SHOREHAM NUCLEAR POWER STATION

SNRC-485

I&E Bulletin 80-08
SHOREHAM NUCLEAR POWER STATION - UNIT 1
Docket No. 50-222

EXAMINATION OF CONTAINMENT LINER PENETRATION WELDS

FIG. 3.8.1-13
 REACTOR CONTAINMENT
 PIPING PENETRATION DETAIL
 SHOREHAM NUCLEAR POWER STATION-UNIT 1
 FINAL SAFETY ANALYSIS REPORT

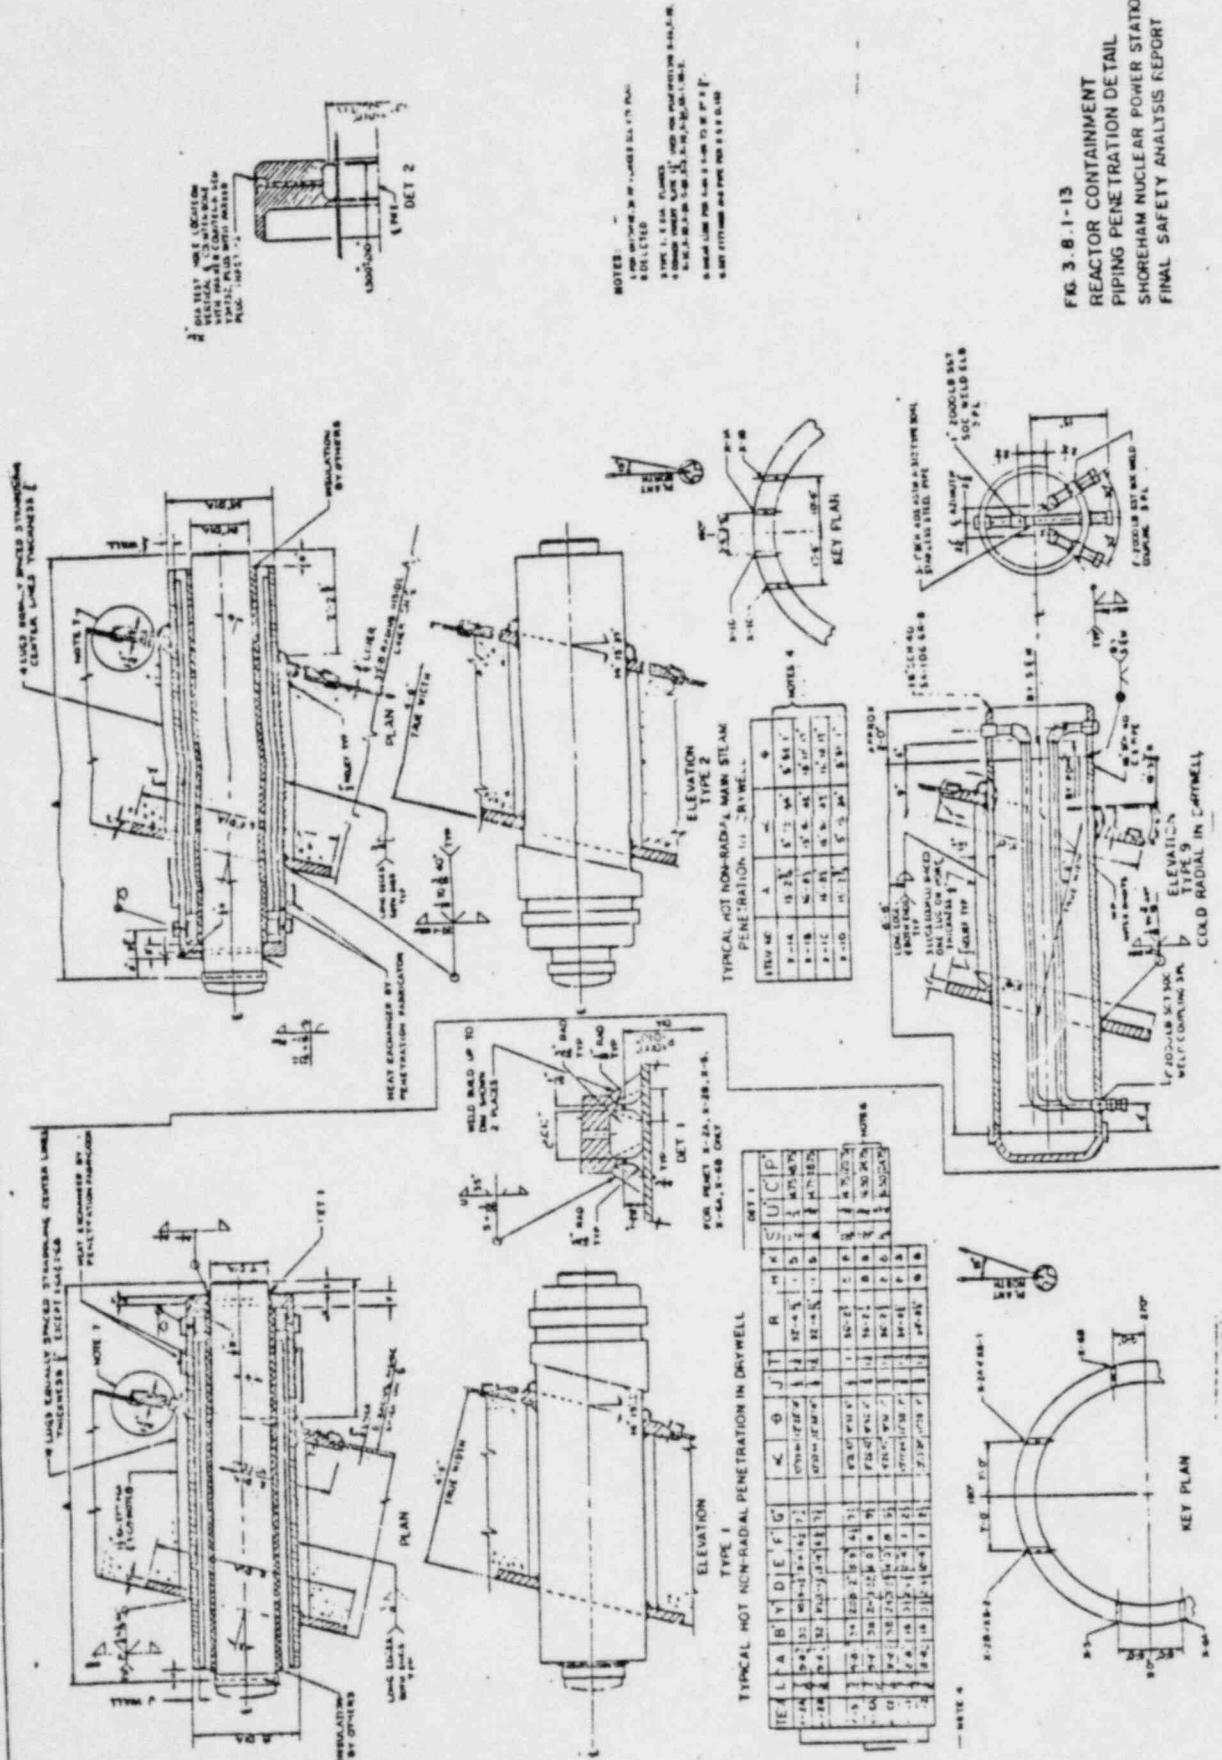
Item 1. Determine if your facility contains the flued head design for penetration connections, or other designs with containment boundary butt weld (s) between the penetration sleeve and process piping as illustrated in Figure NE 1120-1, Winter 1975 Addenda to the 1974 and later editions of the ASME B&PV Code.

Item 2c. Type of weld joint (including pipe material and size) and whether or not backing bars were used.

Response: Flued head penetration connections are utilized in the Shoreham design. The design of the connection between the flued head and the sleeve is shown on Figure 3.8.1-13 of SNPS-1 FSAR. The design is similar to those as shown in Figure NE 1120-1, Winter 1975 Addenda to the 1974 ASME B&PV Code.

Response: The weld joints consisted of full penetration butt welds with backing bars as shown in Figure 3.8.1-13 of SNPS-1 FSAR. The pipe materials and sizes are as listed in Table 1.
